T.Y. LIN INTERNATIONAL
 THE STAMPED DOCUMENTS ARE HEREBY:
 APPROVED
 X APPROVED AS NOTED
 REVISE AND RESUBMIT
 SEE TRANSMITTAL FOR ADDITIONAL INFORMATION AS APPLICABLE.
 THIS REVIEW IS FOR GENERAL CONFORMANCE WITH DESIGN CONCEPT ONLY. ANY DEVIATION FROM THE PLANS OR SPECIFICATIONS NOT CLEARLY NOTED BY THE CONTRACTOR HAS NOT BEEN REVIEWED. REVIEW BY THE ENGINEER SHALL NOT RELIEVE THE CONTRACTOR OF THE CONTRACTUAL RESPONSIBILITY FOR ANY ERRORS OR DEVIATION FROM THE CONTRACT REQUIREMENTS.
 RICK HEBERT REVIEWER 2/2/2015 DATE

NO.	DATE	REMARKS	BY
REVISIONS			
		CASCO BAY STEEL STRUCTURES ONE WALLACE AVENUE SOUTH PORTLAND, ME 04106 PHONE: 207-780-6722 FAX: 207-780-6726	
STRUCTURE <u>BENMONT AVE. (TH-7) (URBAN MINOR ARTERIAL)</u>			
LOCATION <u>TOWN OF BENNINGTON, VERMONT</u>			
PROJECT NO. <u>BRIDGE NO. 57 PROJECT NO. BRF 1000(16)</u>			
ENGINEER <u>STATE OF VERMONT AGENCY OF TRANSPORTATION</u>			
CUSTOMER <u>ALPINE CONSTRUCTION</u>			
ITEM <u>GIRDER ~ 11G1C</u>			
SURFACE PREP. <u>SSPC-SP10</u> OPEN HOLES <u>1/8" (UN)</u>			
PAINT <u>NONE</u>			
APPROVAL	DRAWN <u>GDC</u>	12-9-14	SHEET NO. <u>11AB</u>
SHOP	CHECKED <u>FM</u>	1-5-15	JOB NO. <u>605</u>

Sheet 11AB - Revised: 01/09/2015 @ 08:36 (HEATHER)

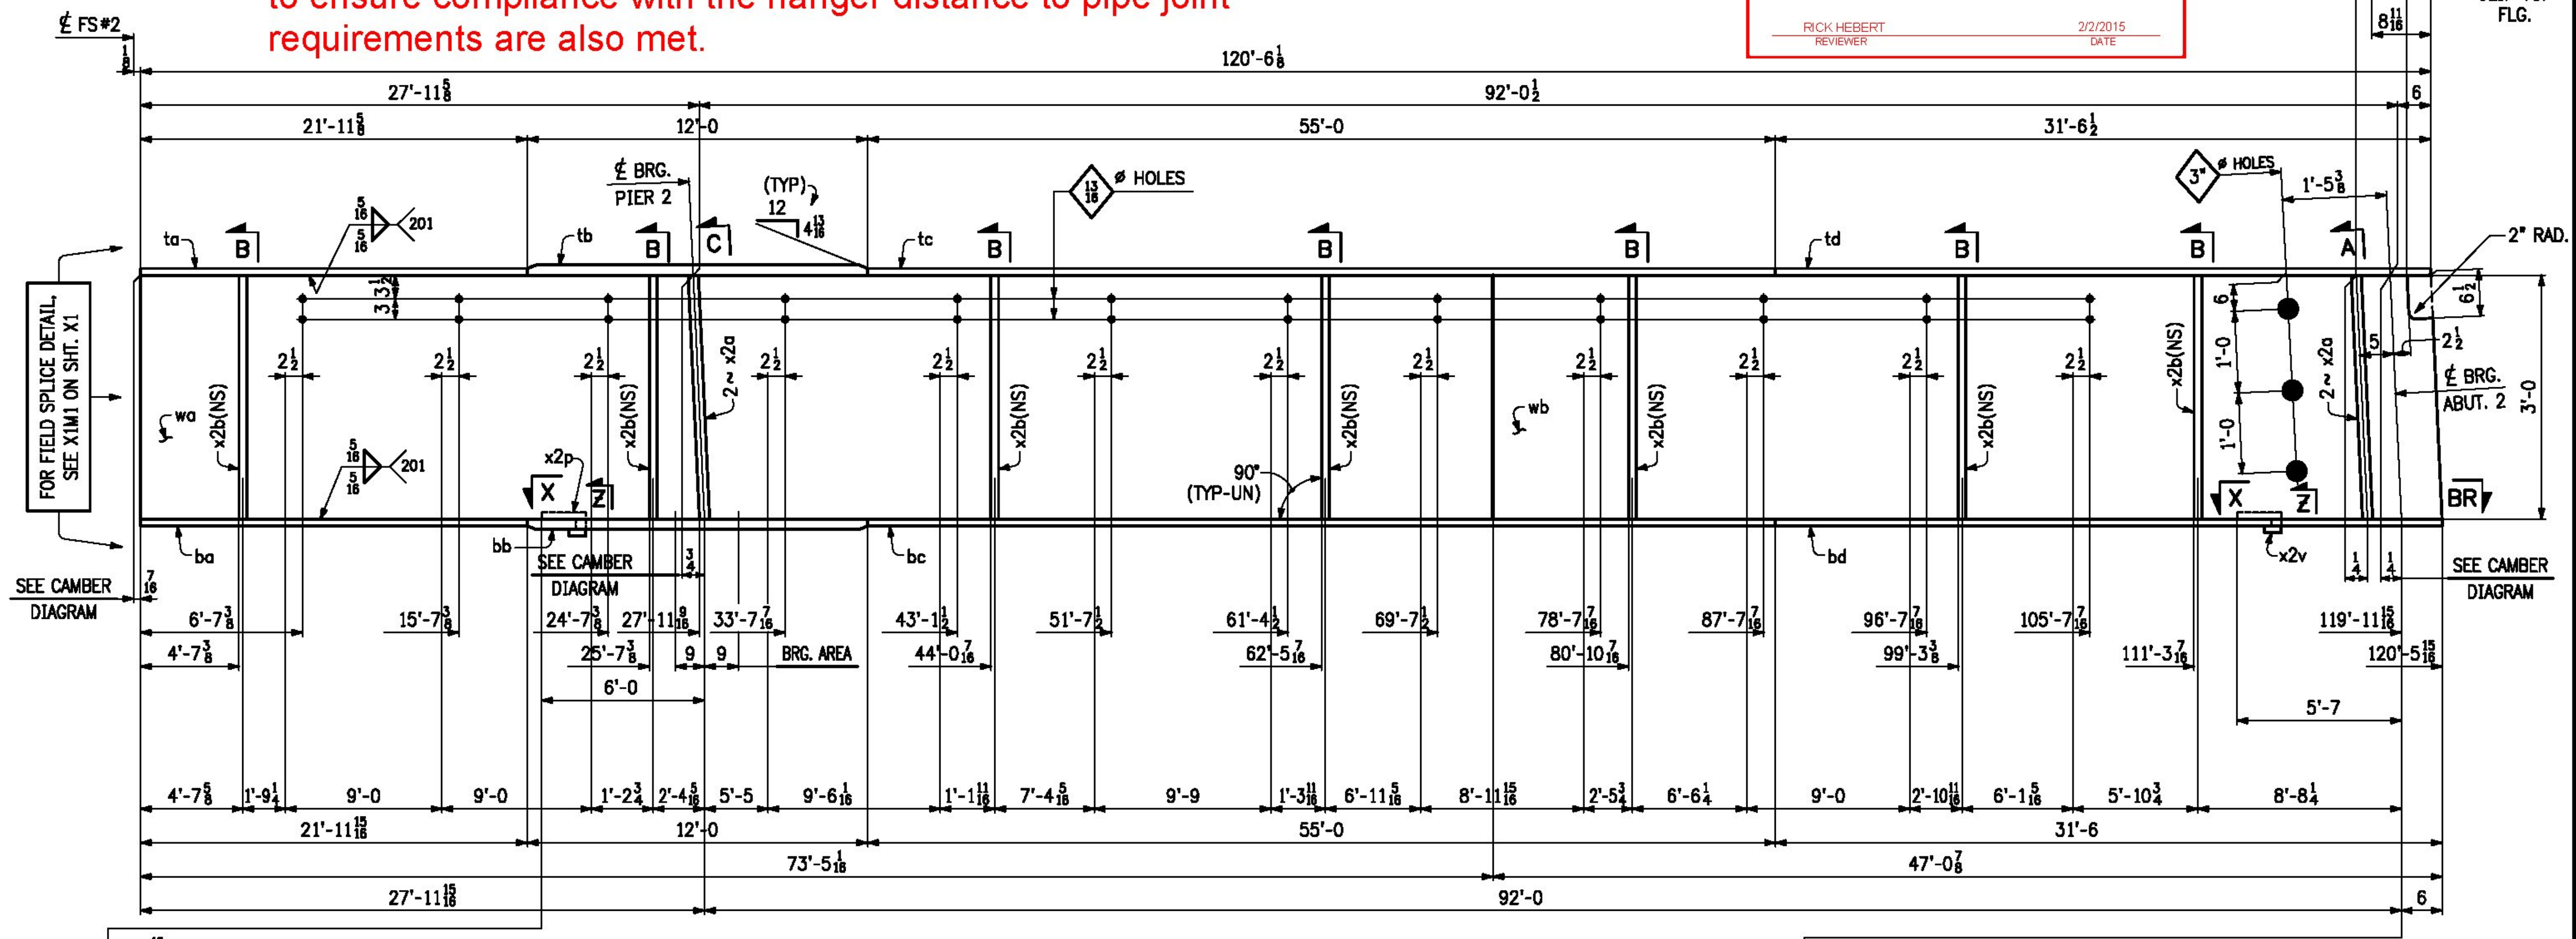
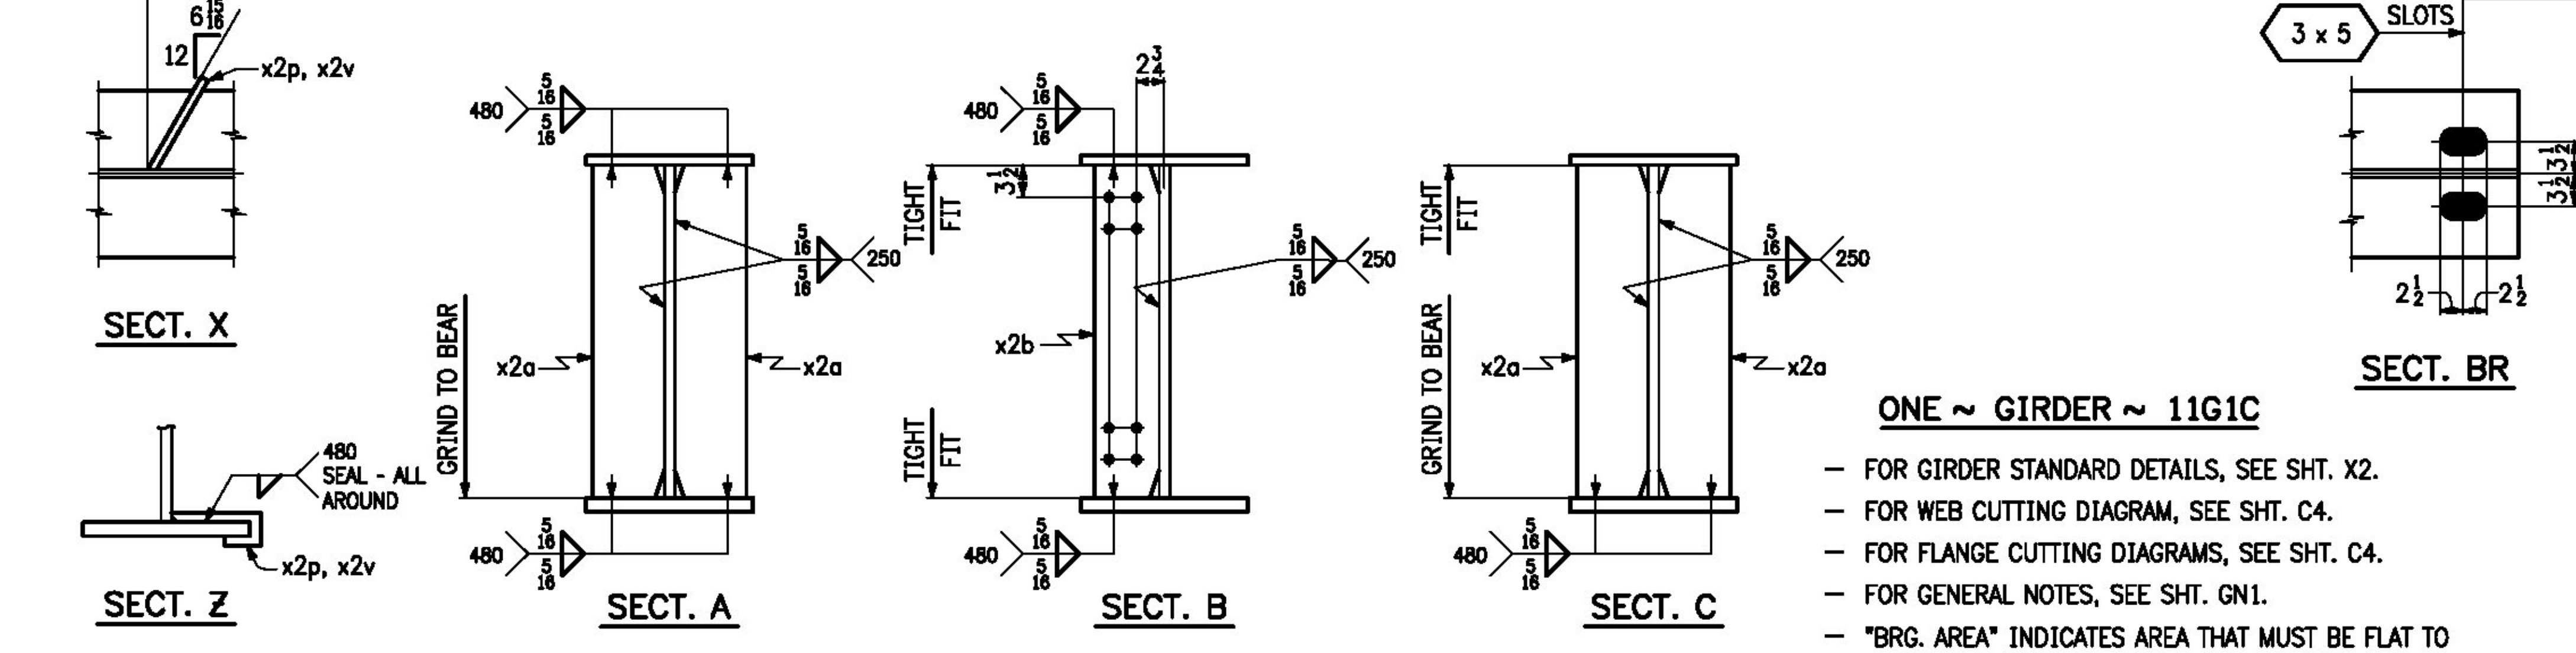
Spacing of waterline support beams are not all at 9'-0" spaces as shown on Contract Drawing Sheet 39 of 75. Maximum variation appears to be 9". The increase in span is acceptable, however the Contractor should refer to the Special Provision (Water Main on Bridge) to ensure compliance with the hanger distance to pipe joint requirements are also met.
